### Seismic Walkdown Checklist (SWC)

Peach Bottom Atomic Power Station Unit 3  
MPR-3812, Revision 3  
Correspondence No. RS-12-173

Equipment ID No. M03-48-3804B Equip. Class<sup>12</sup> (08a) Motor Operated Valves

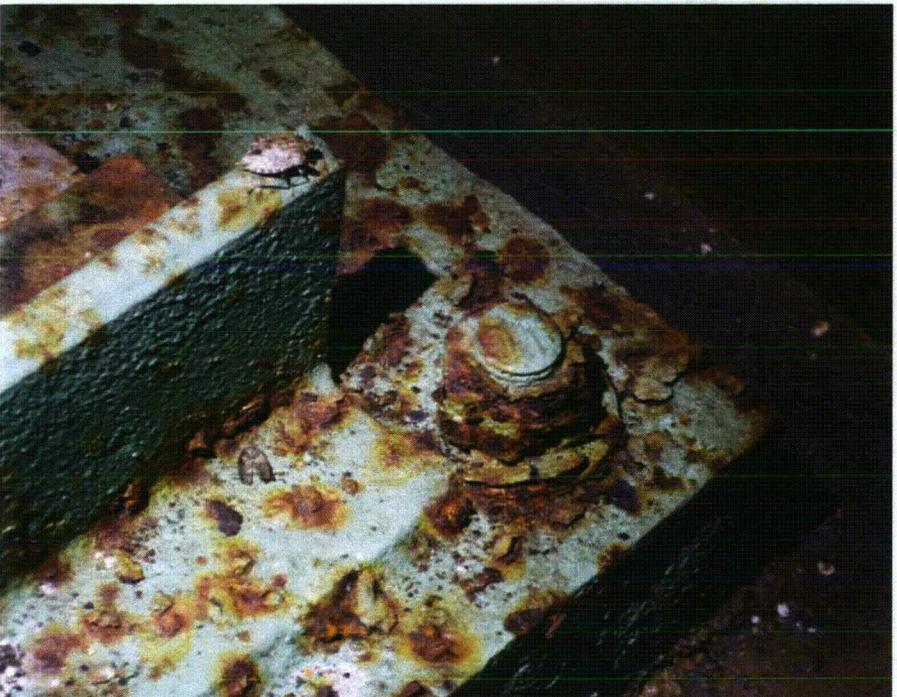
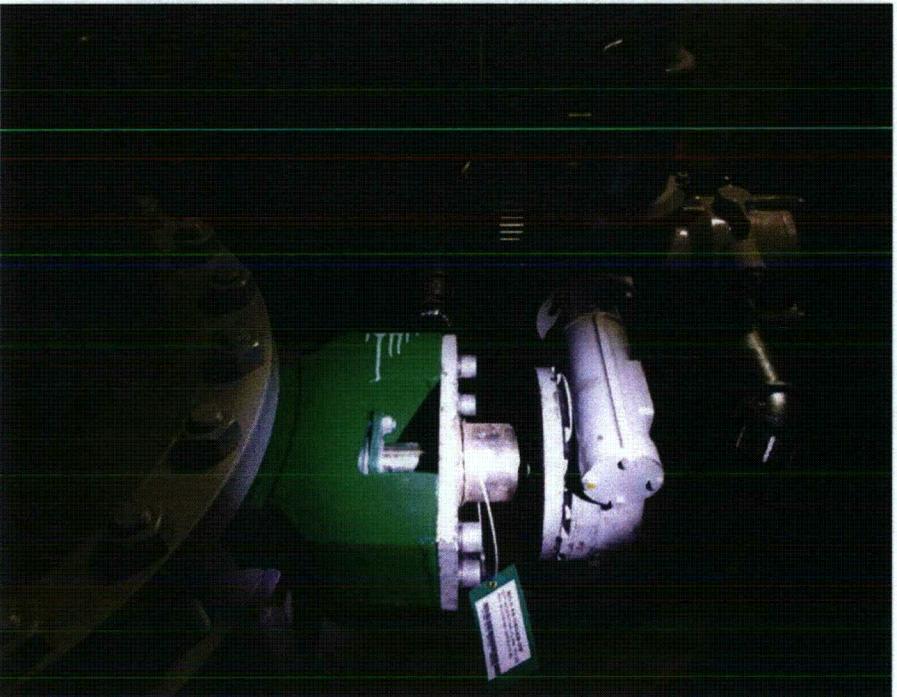
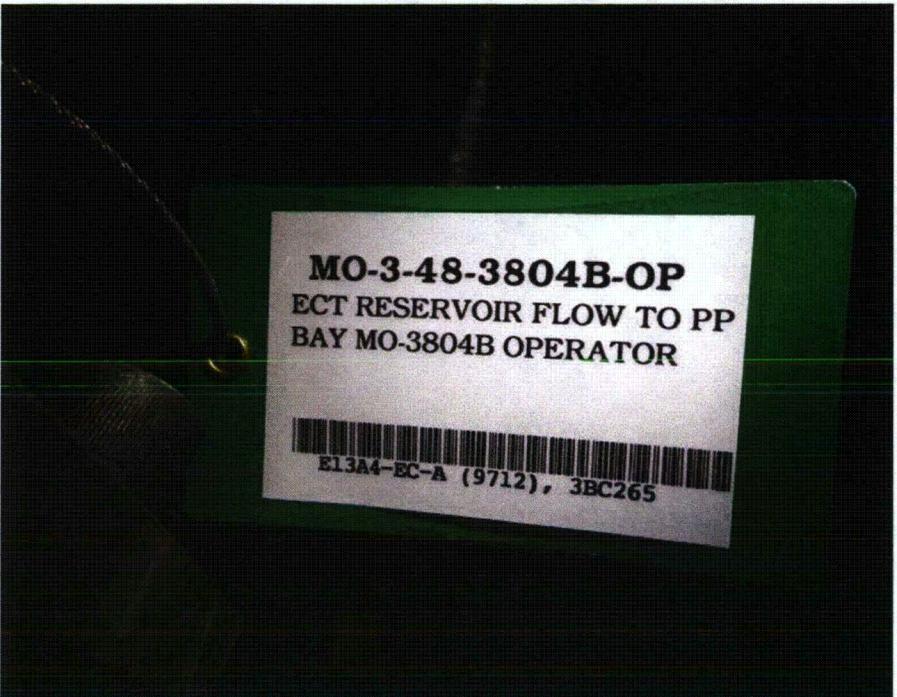
8. Are overhead equipment, distribution systems, ceiling tiles and lighting, and masonry block walls not likely to collapse onto the equipment?  Y  N  U  N/A  
*Lighting properly secured with closed S-hooks  
 It is not credible for falling fluorescent bulbs to damage equipment.*

Equipment ID No. 3 ~~PO20223-3(2)~~ <sup>gmv 8/29/2012</sup> Equip. Class<sup>12</sup> (10) Air Handlers  
POD-3-40H-30223-03 <sup>MO 10/23/12</sup>  
Equipment Description HPSW Pump Room A Loop Supply Damper

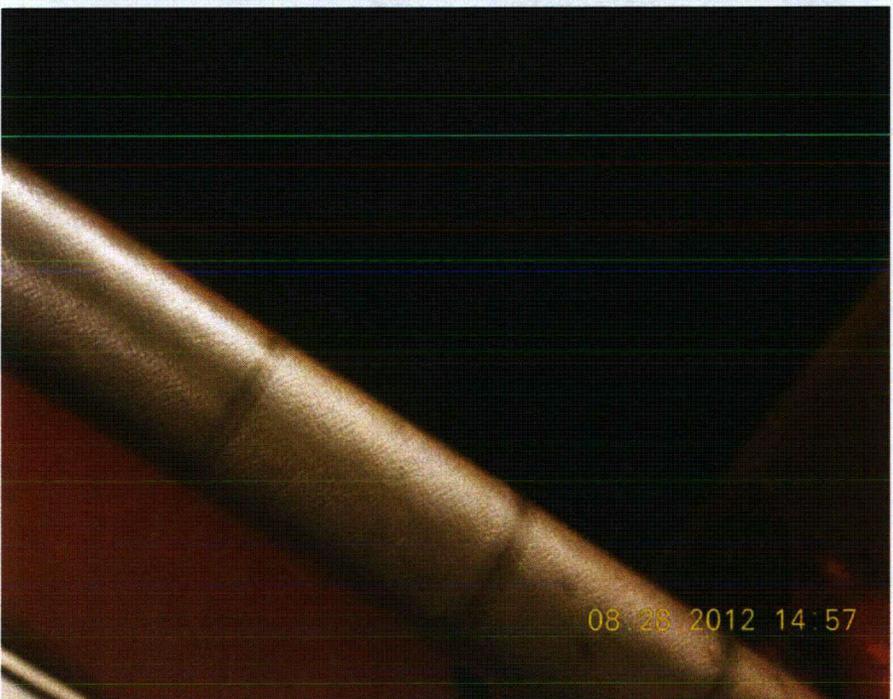
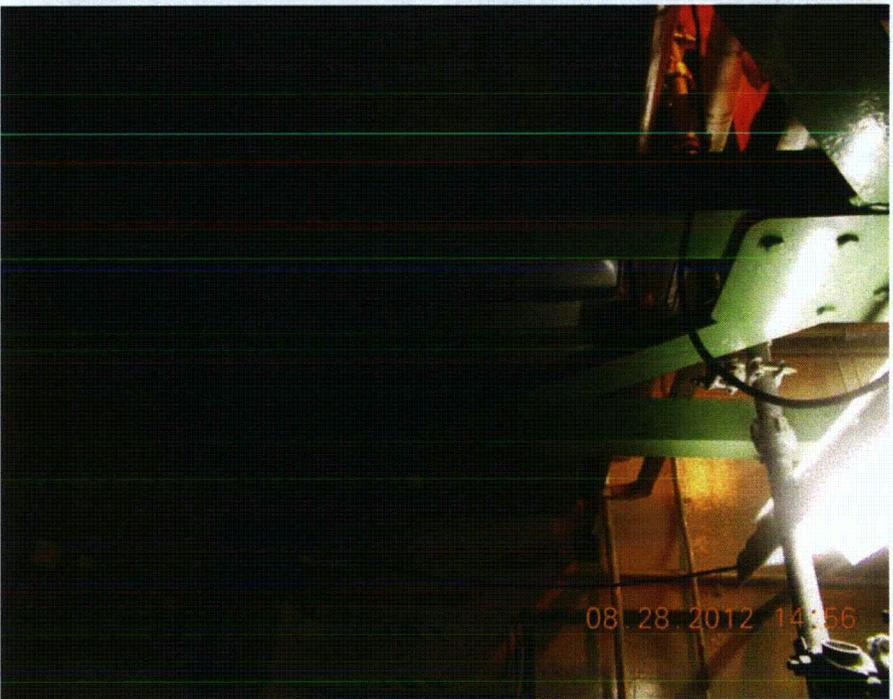
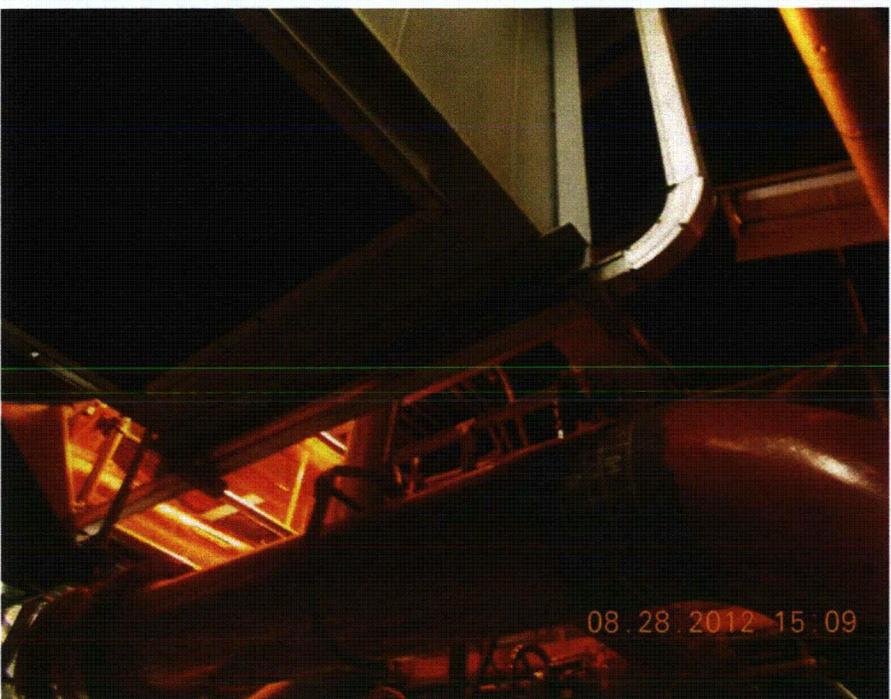
**Comments** (Additional pages may be added as necessary)  
*IPEEE: Tubing routed through protective enclosure mounted to damper support frame and is protected from contact with conduit. KB 9/11/2012*

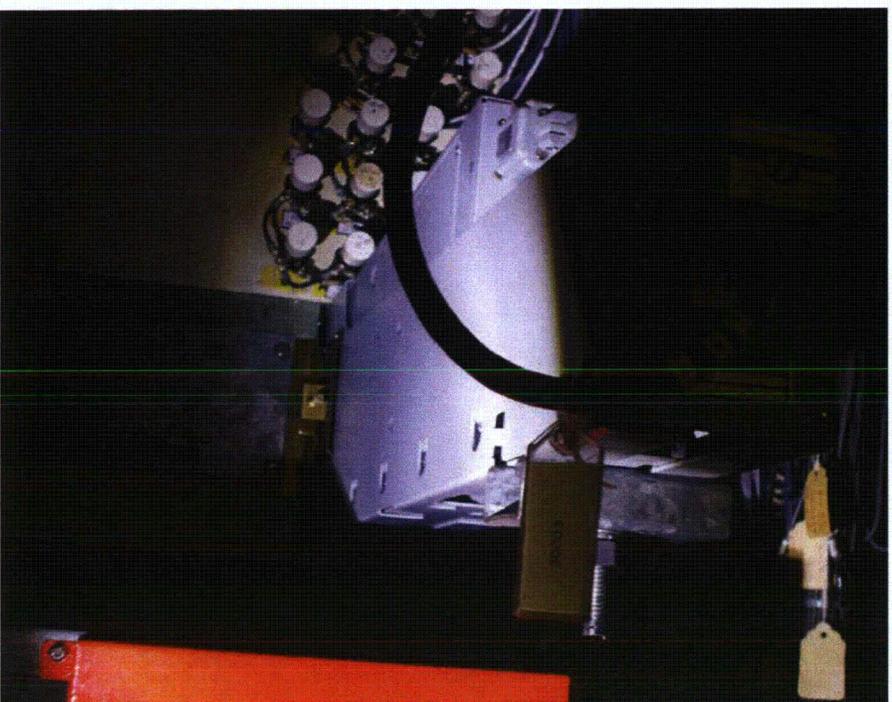
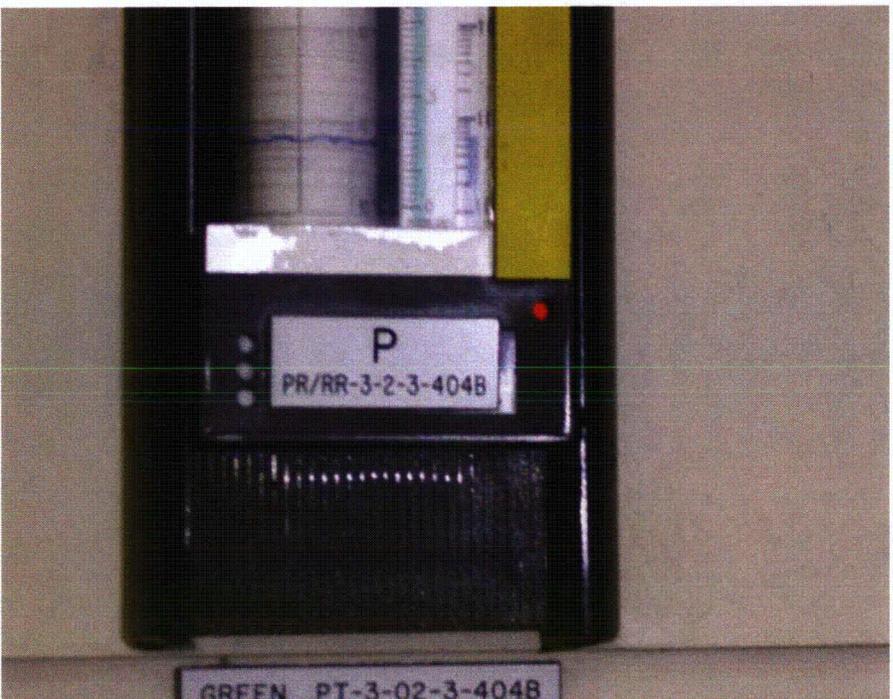
*MCR ceiling consistent with Calc 26-S/2-12, Revision 0.  
Calc G-106-1 could not be located. See IR 01428651.*

Equipment ID: PR/TR-5805

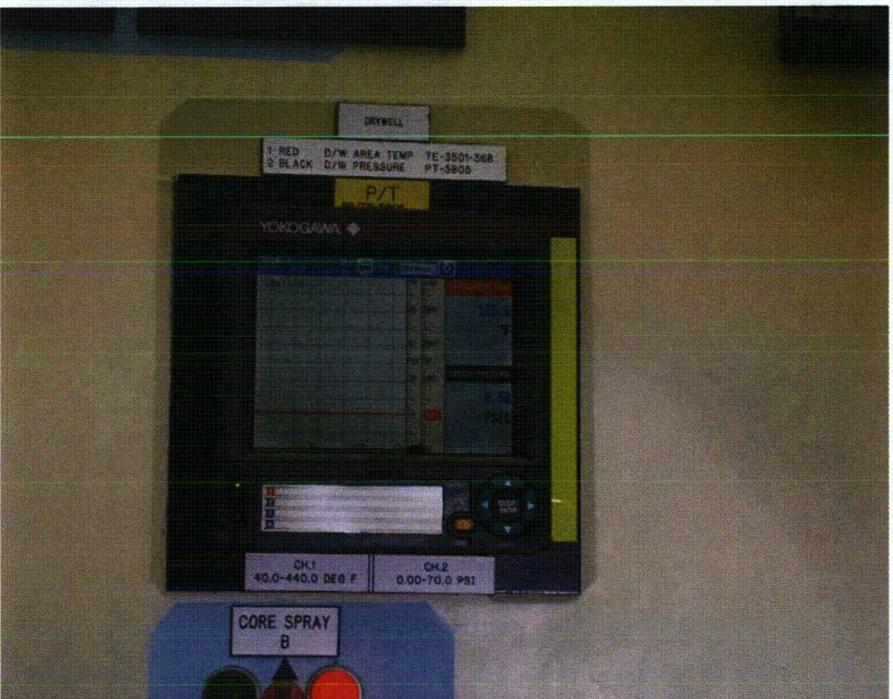
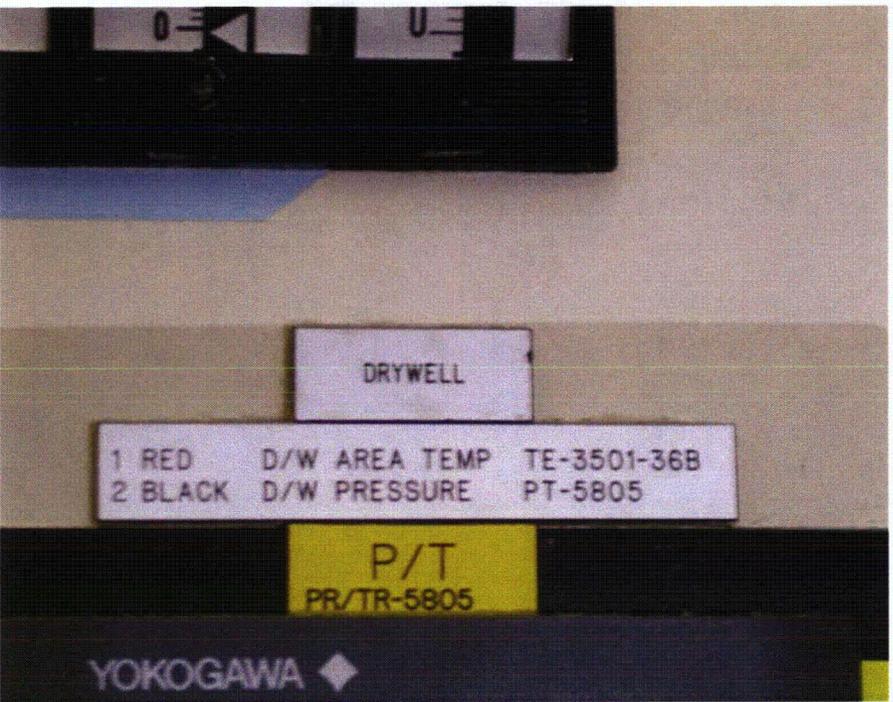
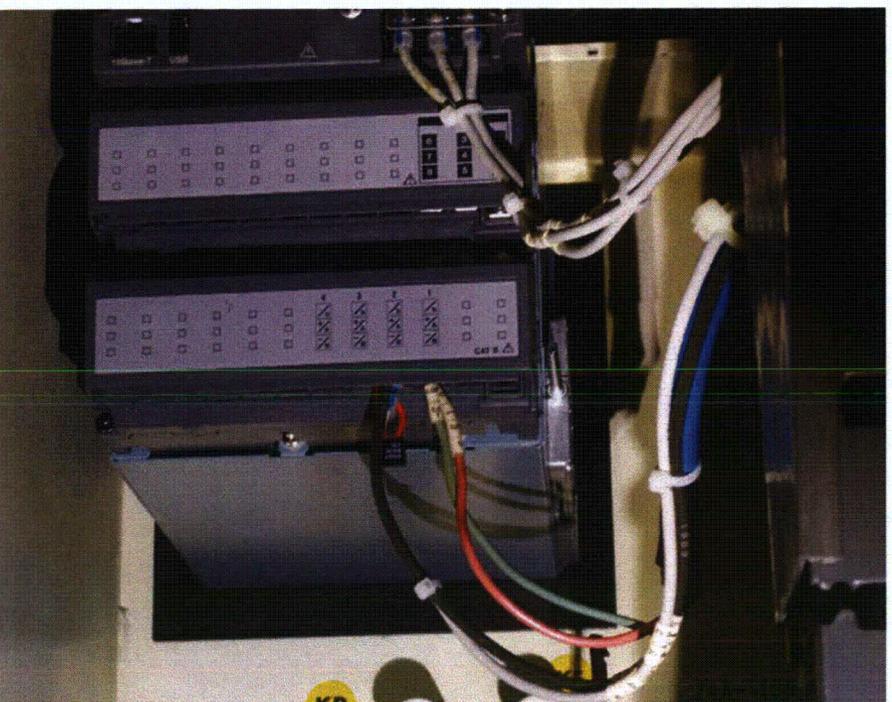
*No attached lines. MO. 8/21/12*

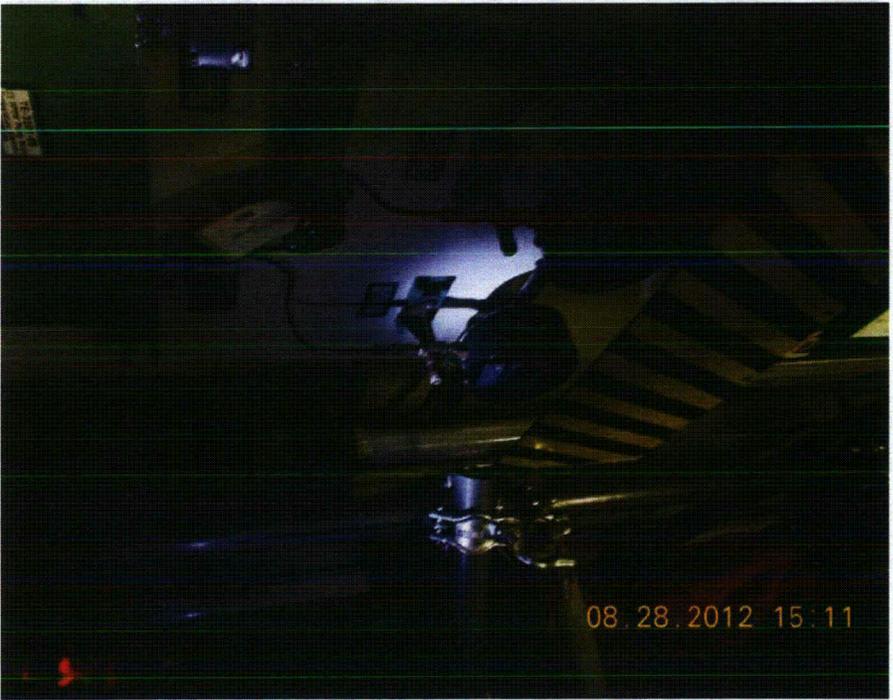
*Nearby scaffolding securely built*

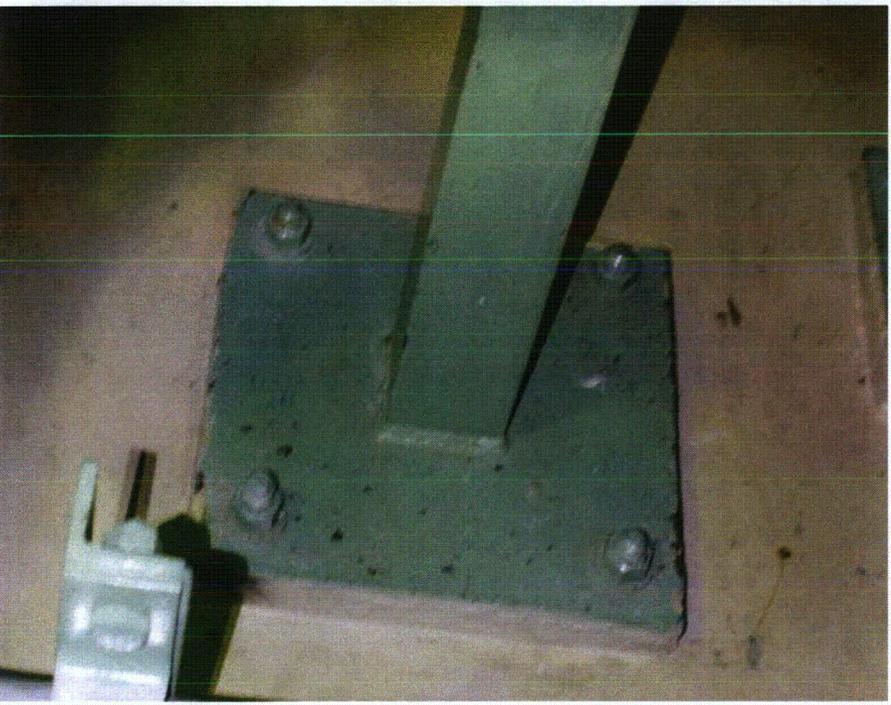
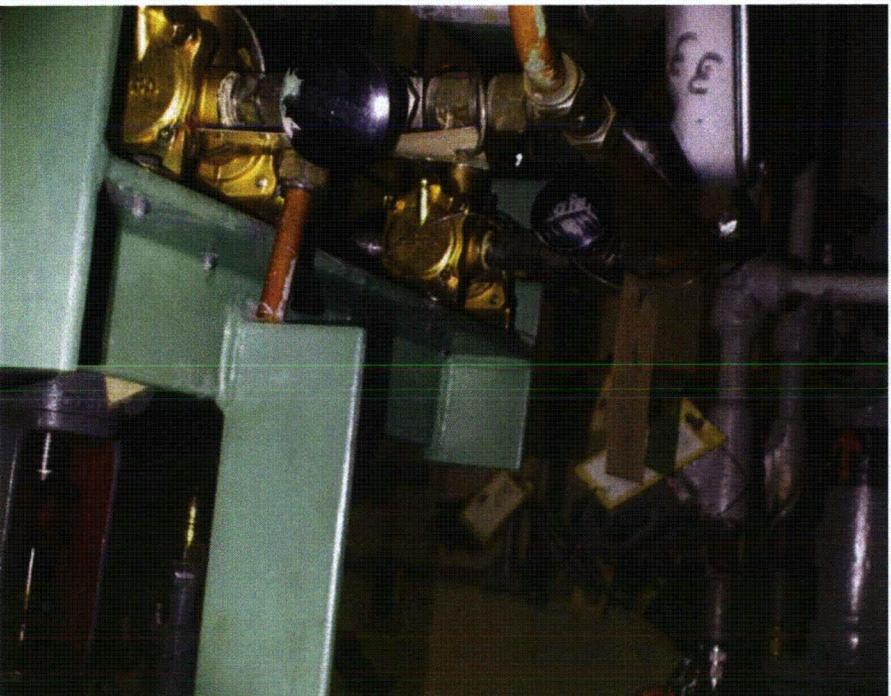
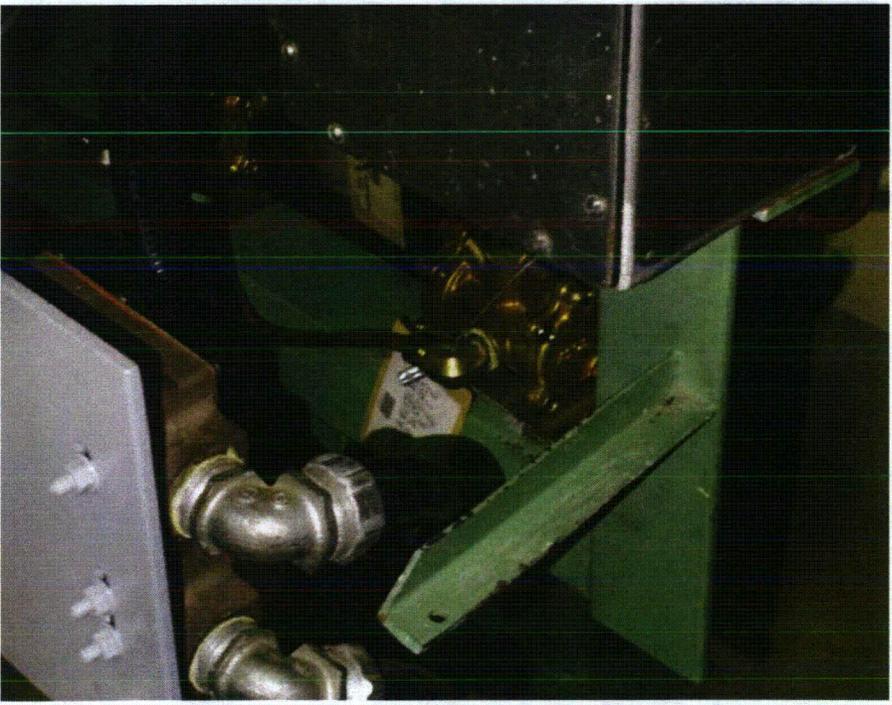
5. Is the anchorage configuration consistent with plant documentation?  Y  N  U  N/A  
 (Note: This question only applies if the item is one of the 50% for which an anchorage configuration verification is required.)  
*Except IR 01413655*

8. Are overhead equipment, distribution systems, ceiling tiles and lighting, and masonry block walls not likely to collapse onto the equipment?  Y  N  U  N/A  
*No II/I concerns identified*
